ADDENDUM #1

September 18, 2017

**UNC Charlotte Sycamore Hall Renovation
Charlotte, North Carolina
SCO #16-12735**

BULLETIN DRAWING TITLE	PROJECT NUMBER
DOOR SCHEDULE REVISIONS, ADDENDUM #1	1610
DRAWING NUMBER	ABD-001
DATE: 09/18/17

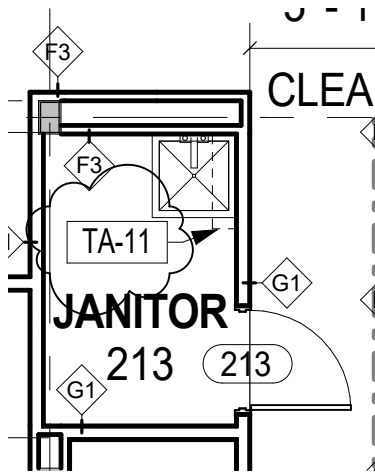
1. ABD-001, Addendum #1 revisions to door schedule.
2. ABD-002, Addendum #1 toilet accessory revisions.

DOOR MARK	Frame Type	Door Material	DIMENSIONS		DOOR			HARDWARE	GLASS TYPE	COMMENTS
			WIDTH	Height	HEAD	JAMB	SILL			
FIRST FLOOR										
100	EXIST		3' - 0"	7' - 0"				18.0	EXIST	EXISTING DOOR - PROVIDE CARD READER AND PANIC HARDWARE
100B	HM-1	WD	2' - 6"	7' - 0"	2A	2B	2C	16.0	NONE	
101	HM-1	WD	3' - 0"	7' - 0"	2A	2B	2C	14.0	NONE	
102	HM-1	WD	3' - 0"	7' - 0"	2A	2B	2C	16.0	NONE	
102B	HM-1	WD	4' - 0"	7' - 0"	2A	2B	2C	13.0	NONE	PROVIDE CARD READER
103	HM-1	WD	3' - 0"	7' - 0"	2A	2B	2C	8.0	NONE	
106	HM-1C	WD	3' - 0"	7' - 0"	1A	1B	1C	12.0	GL-1	
107	HM-E	HM	4' - 0"	7' - 0"	4A	4B	4C	5.0	NONE	
108	HM-1	WD	3' - 0"	7' - 0"	2A	2B	2C	9.0	NONE	
109	HM-1B	WD	3' - 0"	7' - 0"	1A	1B	1C	12.0	GL-1	
110	HM-1	WD	3' - 0"	7' - 0"	2A	2B	2C	12.0	NONE	
SB.1A	EXIST		3' - 0"	7' - 0"				19.0	EXIST	EXISTING DOOR TO RECEIVE NEW HARDWARE, INCLUDING PANIC DEVICES AND HOLD-OPEN
SB.1B	SF		3' - 0"	7' - 0"				2.0	GL-2T	PROVIDE CARD READER

2/AE101 SECOND FLOOR PLAN

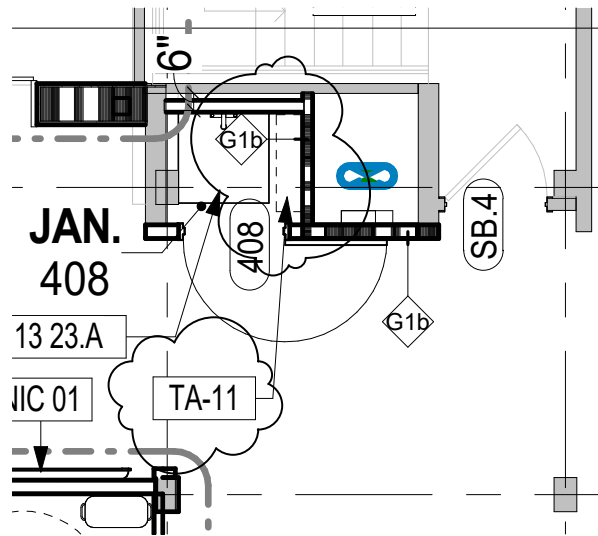
in the unit price specification.	
7	Drawings AE101 and AE102 call for a TA-15 accessory in the janitor closets. Spec section 10 28 00 calls for a Mop and Broom Holder as Item TA-11 but does not list a TA-15. Are the items shown on the drawings intended to be item TA-11?	Toilet accessory TA-15 changed to TA-11, per ABD-002. All janitor storage and mop sink closets to receive a mop and broom holder. See attachment.
8	Is there a logistics plan that the university will issue or is it the responsibility of each contractor to plan for laydown, fencing limits, etc.?	A logistics plan has not been issued, although there are numerous laydown locations near the site. The contractor will work closely with the Architect and UNC Charlotte to determine a logistics plan that functions well for all parties.
9	Are clouded/circled locations on drawing S201 and S202 intended to identify existing slab penetrations that will require repair? Note 4 states that "new and existing slab penetrations are shown"	<p>Clouded/circled locations on drawings S201 and S202 are intended to identify new slab penetrations. Existing slab penetrations are not shown. Existing as-built drawings (FOR REFERENCE ONLY) are available for download; see link below:</p> <p>https://www.dropbox.com/sh/rxlopa76z856olo/AAAkqZBXDEA2kxps_FalJIQla?dl=0</p> <p>Owner and Architect assume no responsibility for the accuracy and completeness of as-built drawings. It is the sole responsibility of the contractor to identify the scope of all work prior to bid.</p>

LOCATIONS.	
NIC-03	PRINTER PROVIDED BY OWNER. SEE ELECTRICAL DRAWINGS FOR OUTLET LOCATIONS.
TA-11	MOP AND BROOM HOLDER
